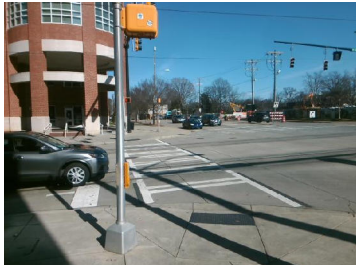
PROW/ADA: TMUTCD 4e.08, R404.2, R404.3, R209.1, MUTCD 4e.10

MUTCD Compliance					
Yes	B 1 Clear Xing Direction?	ClearlyMarked	N/A	B 2 Clear Xing Direction?	N/A
	B 1 Crossing Direction	To NE		B 2 Crossing Direction	N/A
Yes	B 1 DistanceTo XWalk (in)	38.0	N/A	B 2 DistanceTo XWalk (in)	N/A
No	B 1 DistanceTo Curb (in)	80.0	N/A	B 2 DistanceTo Curb (in)	N/A
Yes	B 1 Diameter (in)	2.0	N/A	B 2 Diameter (in)	N/A

Possible Solutions: Replace Signal Push Button With APS Button on New Post. Remove & Relocate Sign.
